USE ON REVIEW REPORT

► **FILE #:** 9-A-19-UR

► **APPLICANT:** HARLEY E. BITTLE, III

► **PROPOSED USE:** Commercial businesses including a restaurant, retail space and a tire sales and service center.

MPC01
 SITE LAYOUT PLAN
 DRAWING

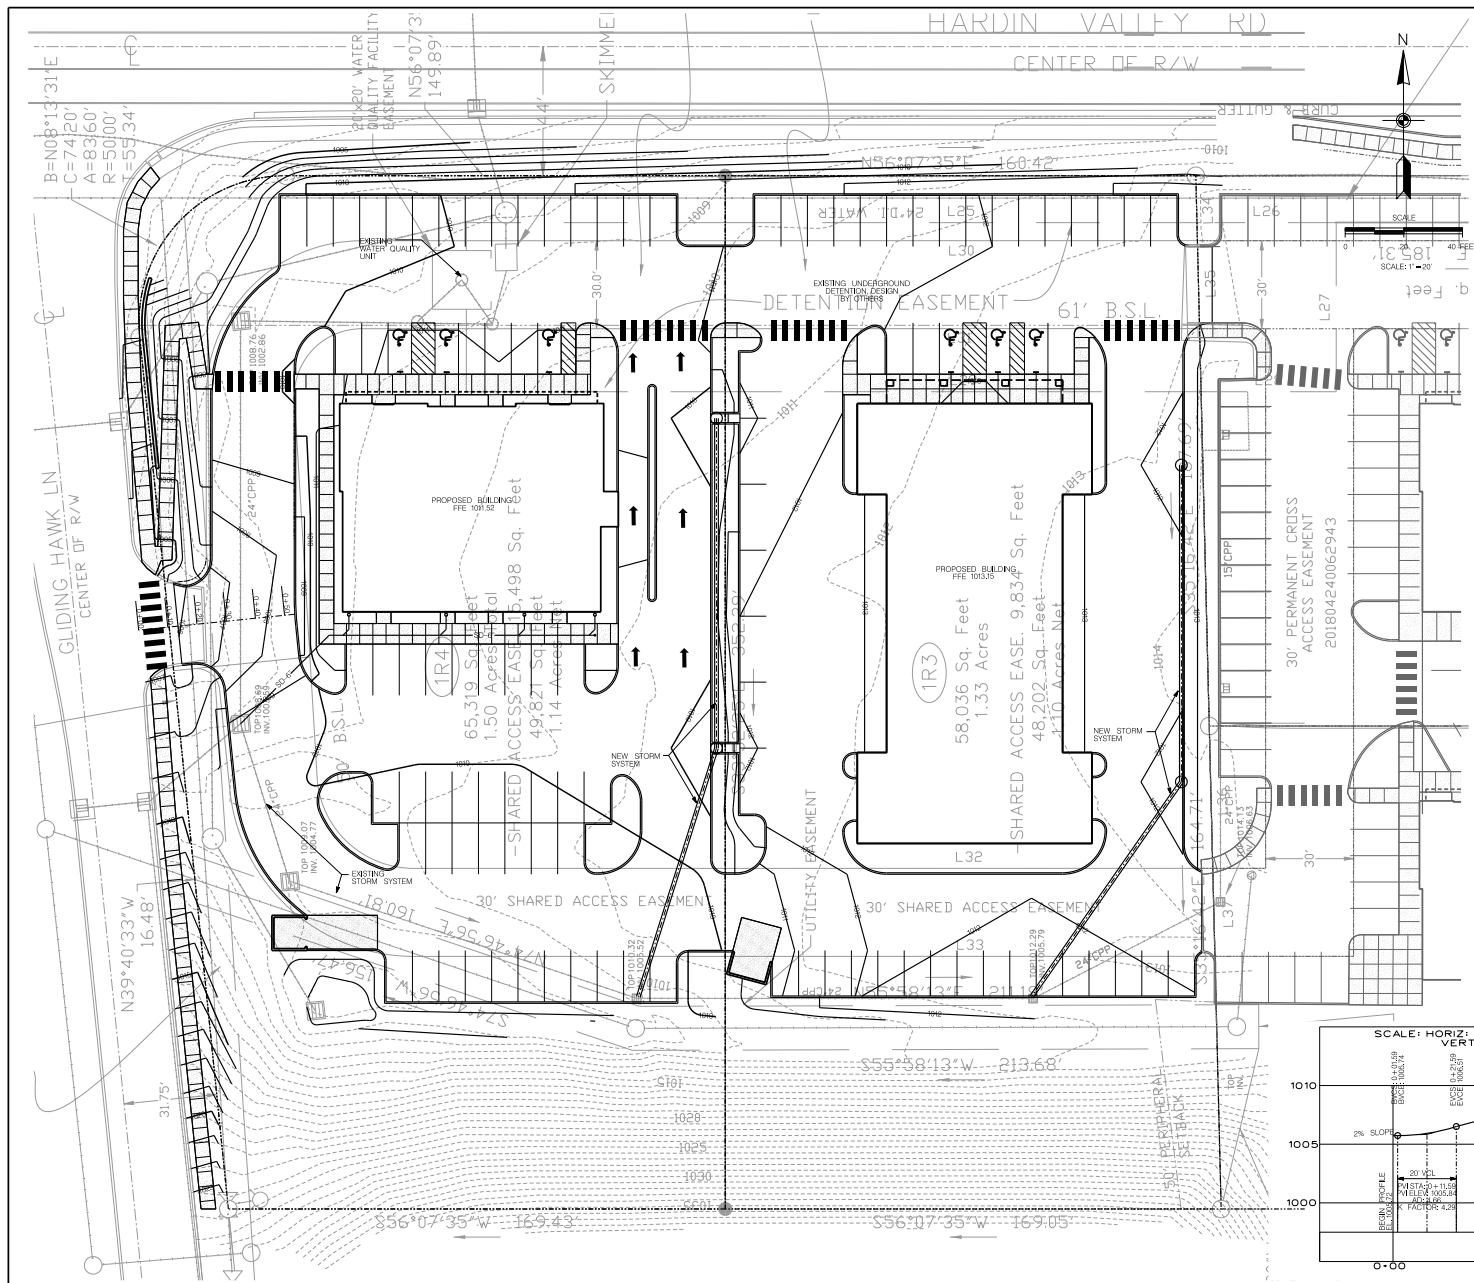
► **APPROVE** the request for two commercial buildings with a total building area of approximately 16,585 square feet, as shown on the development plan, subject to 8 conditions

2. Connection to sanitary sewer and meeting any other relevant requirements of the utility provider.
3. Installation of all sidewalks and any required crosswalks as identified on the development plan, subject to meeting Americans with Disabilities Act (ADA) requirements and the requirements of the Knox County Department of Engineering and Public Works. This includes the sidewalks along Gliding Hawk Ln. from the existing sidewalk along Hardin Valley Rd. to the southern property line for this site with connections to the internal sidewalk system. The crosswalk and lane markings shall also be installed for Gliding Hawk Ln at the intersection with Hardin Valley Rd.

4. Installing all landscaping as identified on the landscape plan within six months of the issuance of an occupancy permit for this project, or posting a bond with the Knox County Department of Engineering and Public Works to guarantee such installation. Landscaping shall be installed so as not to interfere with the sight triangles and visibility along public streets.

Access for the site will be out to Gliding Hawk Ln to the west, and the interior driveways for the retail center located on the east side of the site. There is no direct access out to Hardin Valley Rd. Sidewalk connections are proposed from the retail center to the east and the sidewalks that will be installed along Gliding Hawk Ln with a connection out to the sidewalks along Hardin Valley Rd.
